Access Compliance Report

Public Rights-of-Way

| Intersection ID: 13137 | Main Street: CENTRAL_AV | Cross Street: THOMAS_AV | Location: NE |
| ADA ID: E8402D9D8A82 | Ramp Type: Perp | Initial Pass/Fail: Fail | Overall Compliance: No |

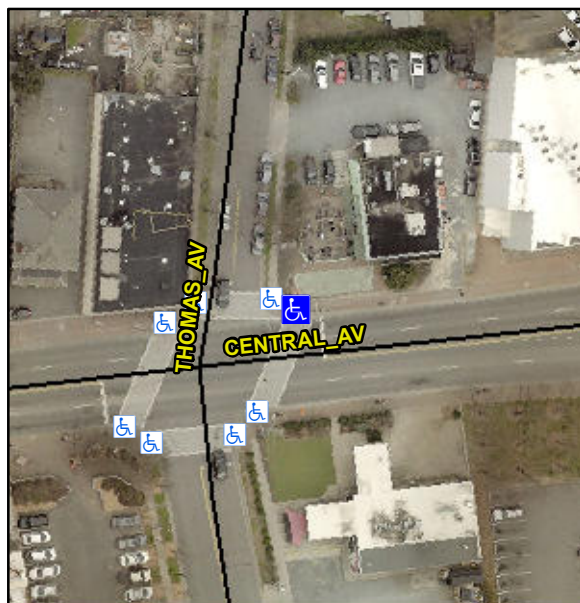
Not Found, R304.2.2

| Compliance | Description | Data | Compliance | Description | Data |
|------------|-----------------------|-------|------------|-----------------------------|------|
| N/A | Ramp Length (in) | 66.0 | No | Ramp Slope (%) | 8.4 |

Remove & Replace Entire Ramp.
